Sydney North Planning Panel

JRPP No	2016/SYE126
DA Number	LDA 2016/0448
Local Government Area	City of Ryde
Proposed Development	Amending DA to the approved Melbourne Building which will increase the maximum height of the building envelope by adding 10 levels of residential apartments comprising of 60 additional units.
Street Address	110-114 Herring Road Macquarie Park
Applicant	HSH Hotels (Australia) Ltd
Number of Submissions	7 Submissions
Regional Development Criteria (Schedule 4A of the Act)	General Development over \$20 Million – Cost of works: \$57,177,223 (for the whole Melbourne Building).
List of All Relevant s79C(1)(a) Matters	• Environmental Planning and Assessment Regulation 2000; • Environmental Planning and Assessment Act 1979; • State Environmental Planning Policy (State and Regional Development) 2011; • State Environmental Planning Policy No. 55 – Remediation of Land; • State Environmental Planning Policy (Building Sustainability Index: BASIX); • State Environmental Planning Policy No 65 – Design Quality of Residential Apartment Development; • Sydney Regional Environmental Plan (Sydney Harbour Catchment) 2005; • Ryde Local Environmental Plan 2014; and • City of Ryde

Figure 8: Apartment below the cantilever and slab.

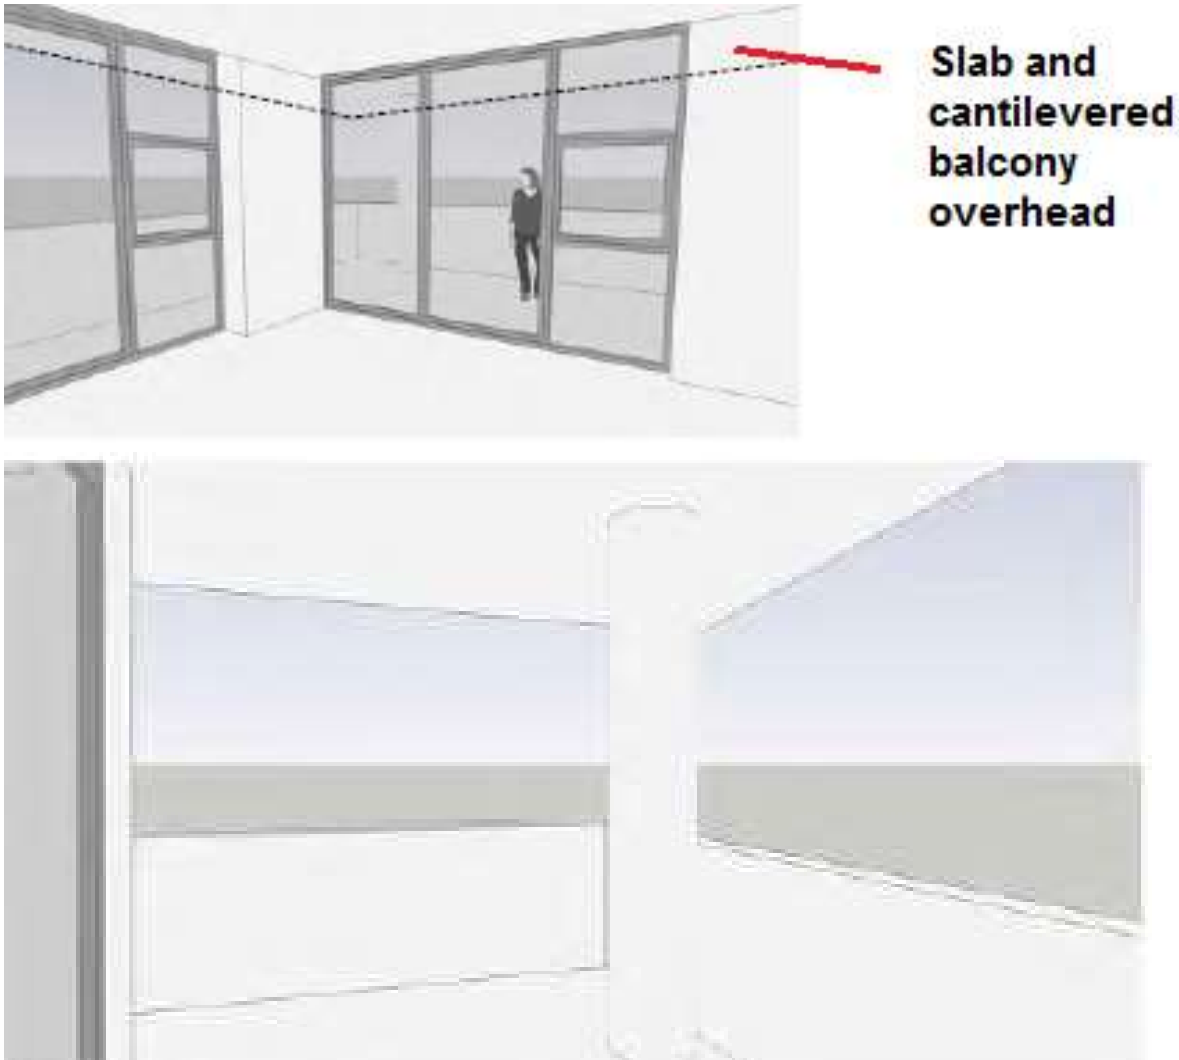
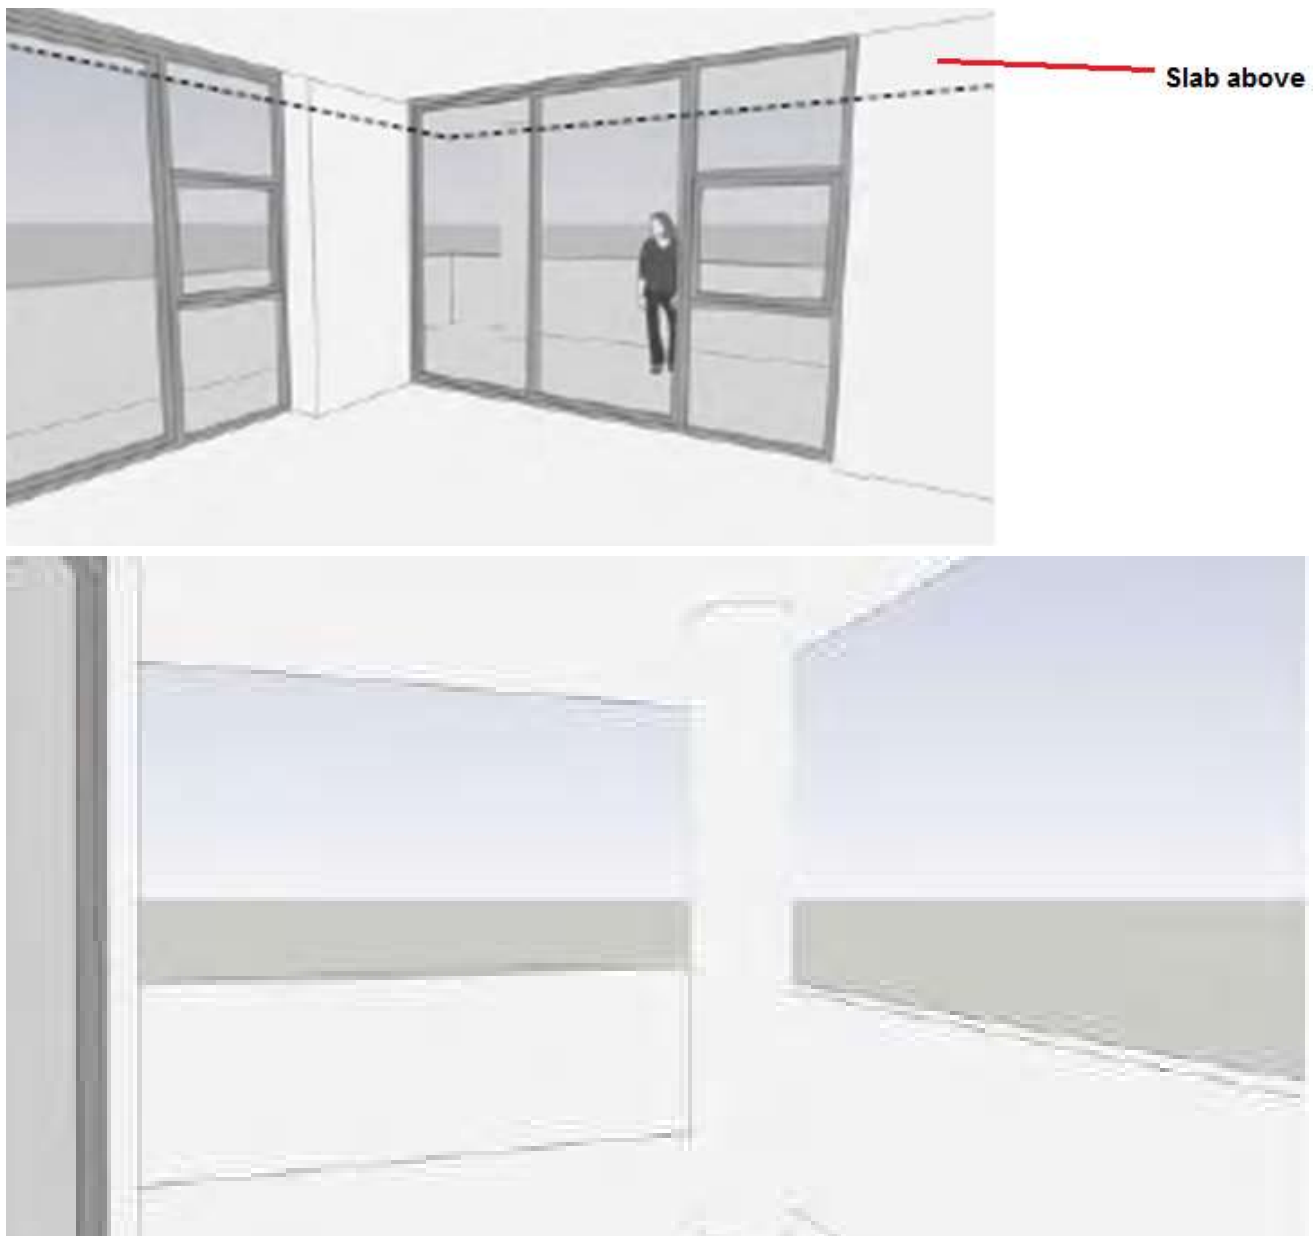
- *The floor plans appear to indicate that the new floor cantilevers beyond the upper floors of the approved building below. This is a concern as it will potentially impact the amenity of units below. This should be avoided where possible.*

The applicant has advised that the cantilevering impacts a single apartment, M1501 and have provided a sketch showing apartment M1501 with and without the offset cantilevered balcony profile, see Figures 8 & 9. The view shown is of the greatest cantilever dimension, which demonstrates the difference is barely noticeable, accordingly the cantilevered balcony overhead has no negative impact on the apartment amenity and does not require modifying. M1501 and the above stack is compliant with the ADG for natural ventilation, daylight access and apartment aspect.

Figure 10: Additional shadow shown in red.

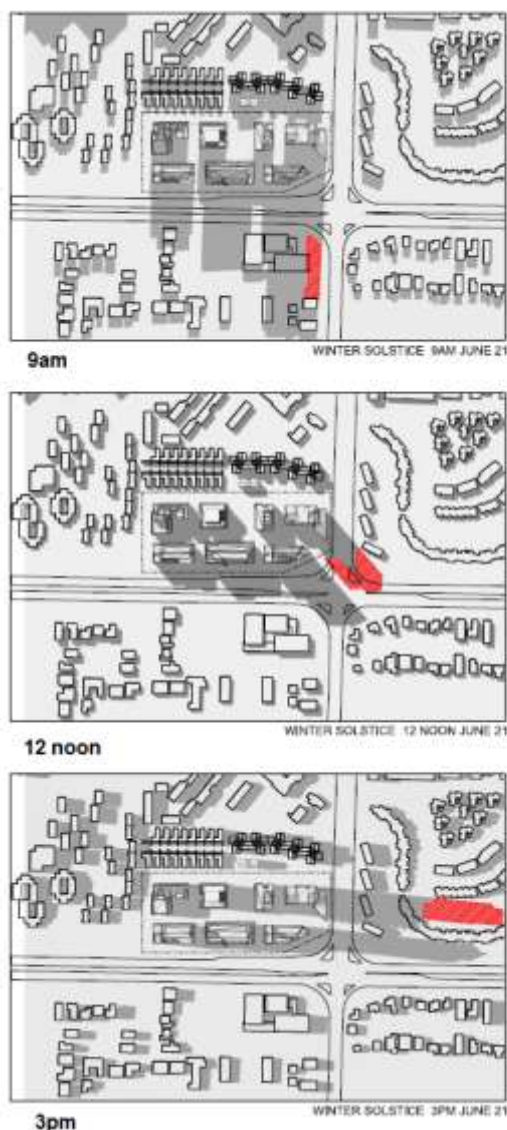
In addition, the DPE assessed the proposal and noted that the provided shadow diagrams, see Figure 10 below, demonstrate that the increased shadow will be relatively minor and will predominantly affect the roadway of the Epping Road/Herring Road intersection. It was noted that whilst there will be an increase in overshadowing to some units within the Sydney Building compared to the previously approved scheme, the DPE considered this to be acceptable as the modified Melbourne Building will comply with the
